MORGANTOWN BOARD OF ZONING APPEALS

COMBINED STAFF REPORT

CASE NO: V16-40, V16-41, and V16-42 / Seneca Village, LLC / 709 Beechurst Ave.

PLANNING AND ZONING CODE CONFORMITY REPORT

SHEET No.
A7.00

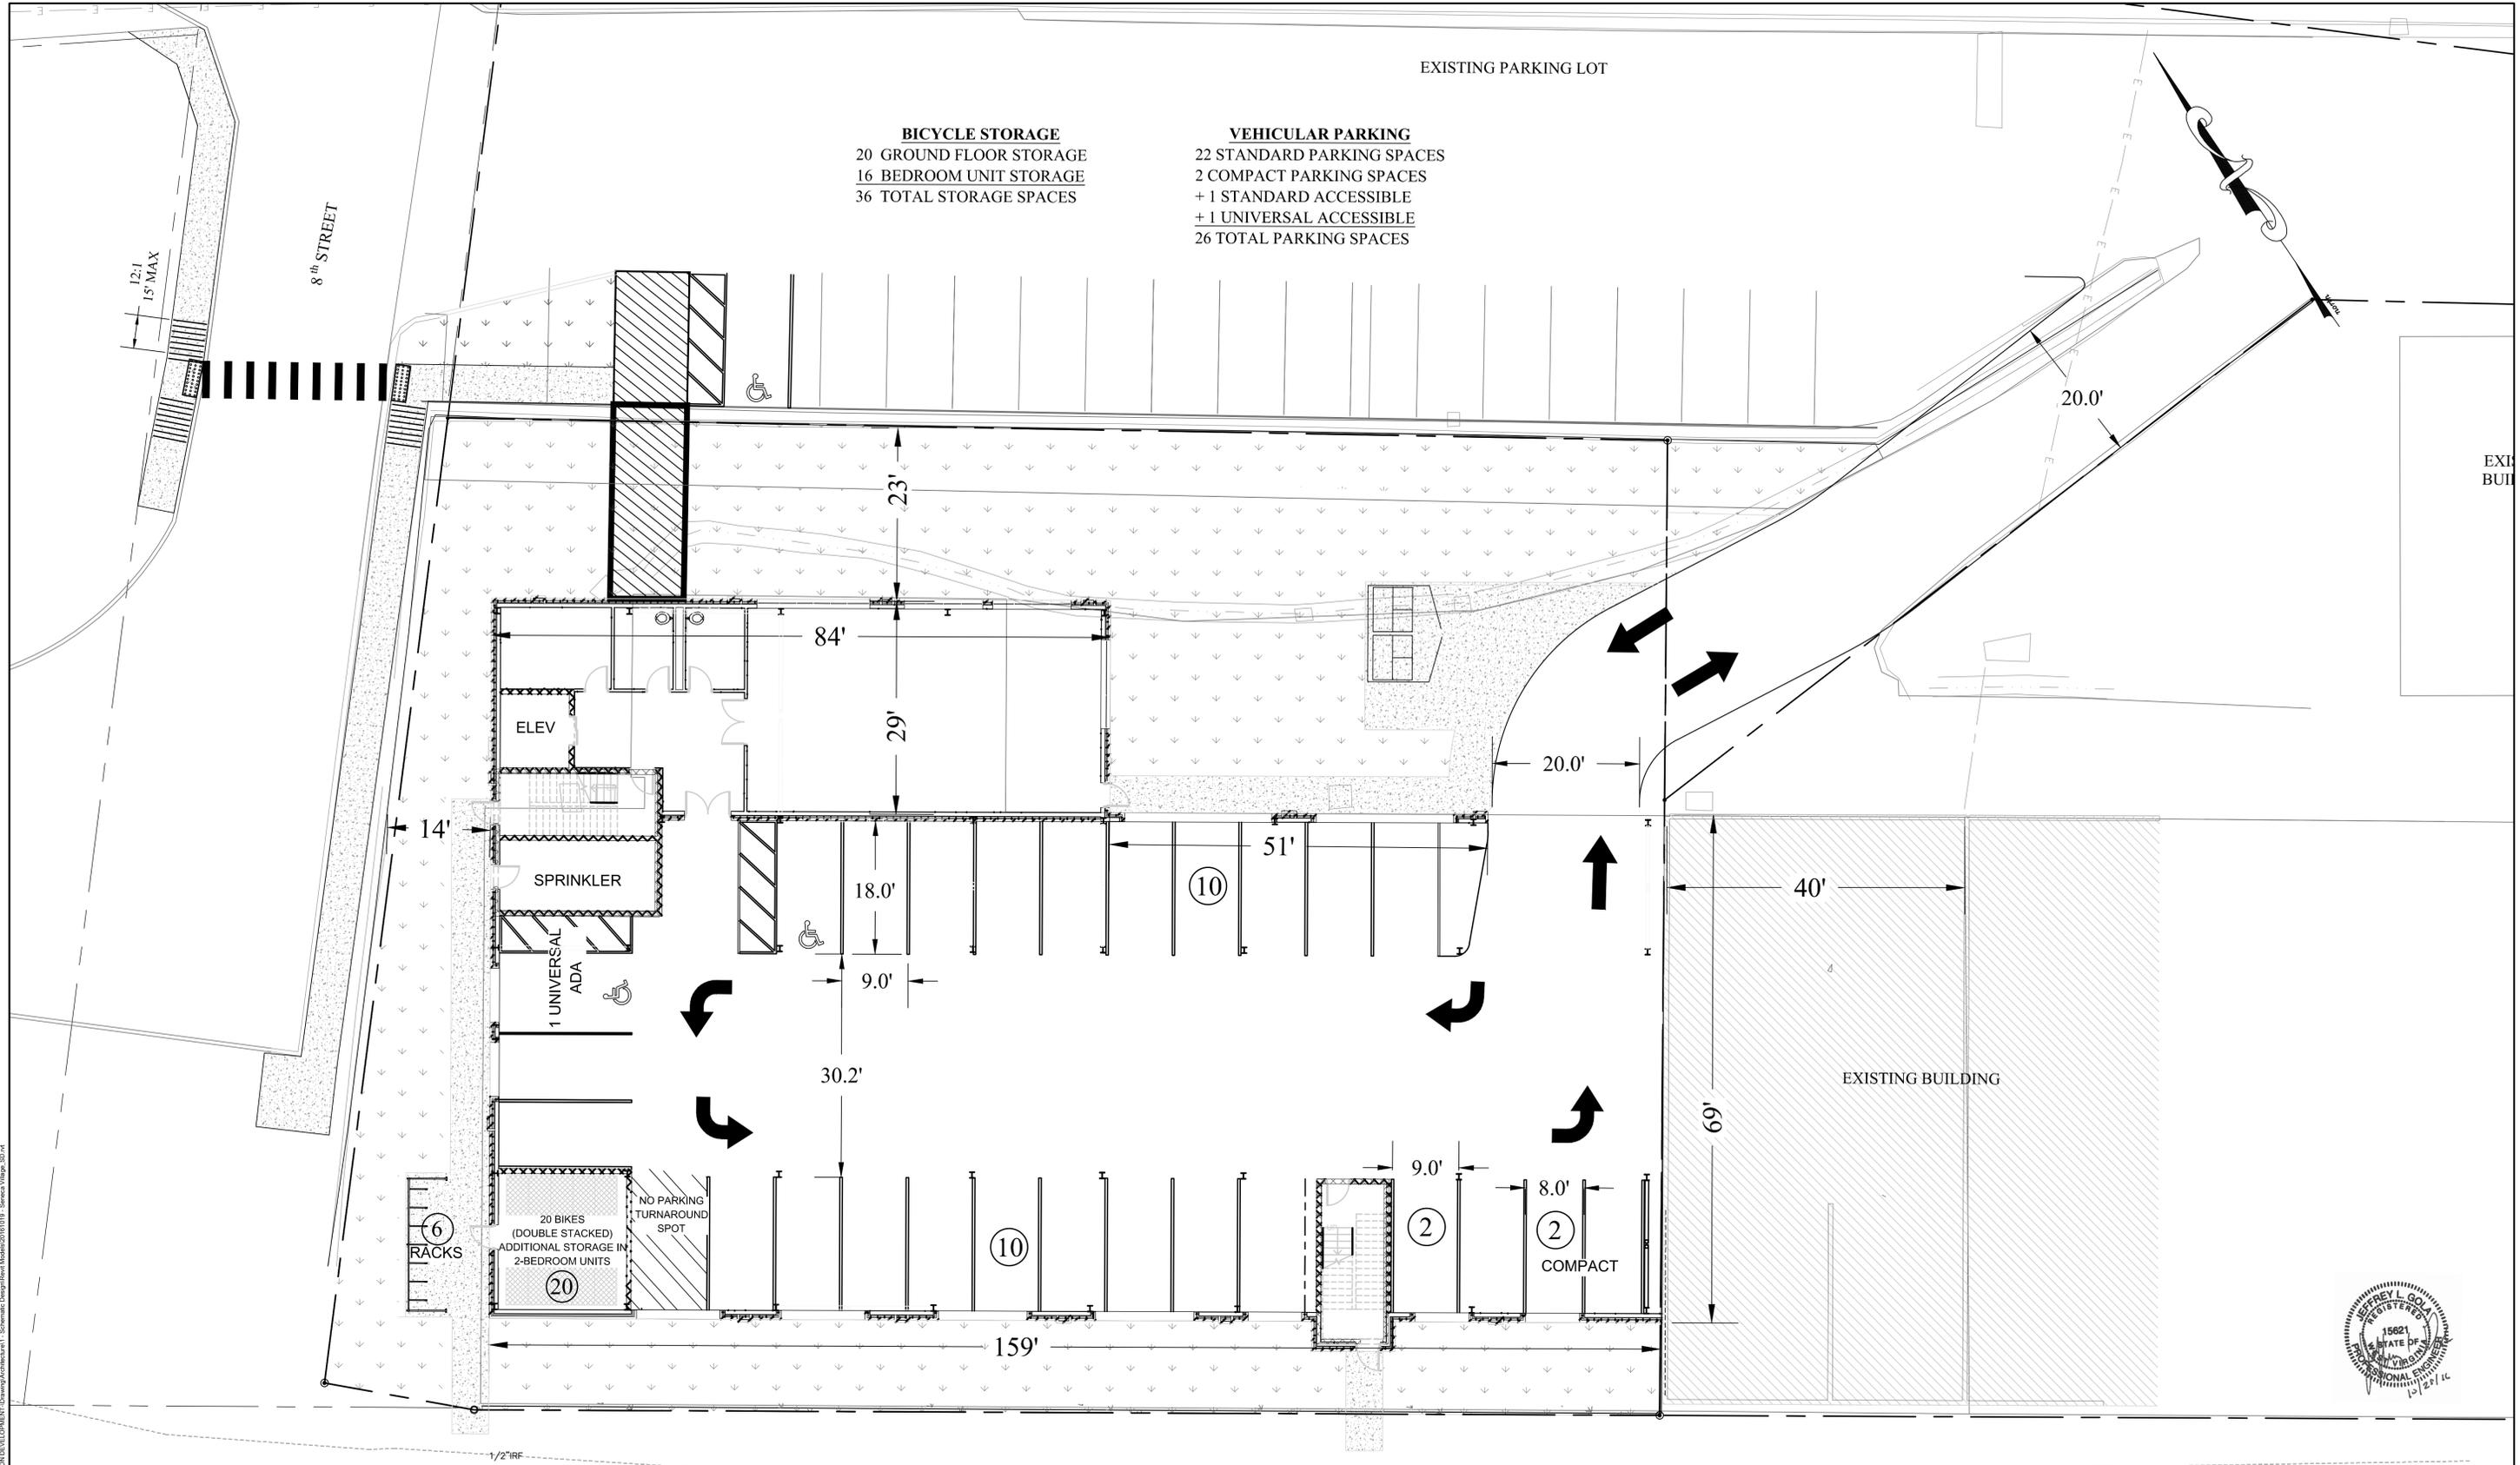
1347.05 Building Height, Use and Size	
Y	(A) The maximum height of a principal structure shall not exceed seventy-two (72) feet, except as provided in Section 1363.02(A), Height Exceptions. <i>The north elevation on Sheet N. A7.00 illustrates a hip roof. It appears the dimension between the peak and eave of the hip roof is 8 feet. As such, it appears the overall height of the contemplated building is approximately 68'-4".</i>
N/A	(B) The maximum height of an accessory structure shall not exceed twenty (20) feet. <i>No accessory structures appear to be included on schematic plans reviewed herein.</i>

Y	<p>(C)(2) Materials. Roofs should be clad in slate, sheet metal, corrugated metal, and/or diamond tab asphalt shingles.</p> <p><i>“Standing Steam Metal Roof” is labeled for the hip roof on Sheets A7.00 and A7.01.</i></p>
N/A	<p>(C)(3) Materials. The orders, if provided, should be made of wood or cast concrete.</p>
N/A	<p>(D)(1) Techniques. Windows should be set to the inside of the building face wall.</p> <p><i>This standard is superseded by Article 1361.03(O)(6).</i></p>
Y	<p>(D)(2) Techniques. All primary entrance exterior doors should have rectangular recessed panels or glass.</p> <p><i>The primary entrance illustrated on the “North Elevation” of Sheet A7.00 appears to be double glass doors.</i></p>
Y	<p>(D)(3) Techniques. All rooftop equipment that is enclosed should be enclosed in building material that matches the structure or is visually compatible with the structure.</p> <p><i>Sheets A7.00 and A7.01 illustrate a hip roof.</i></p>
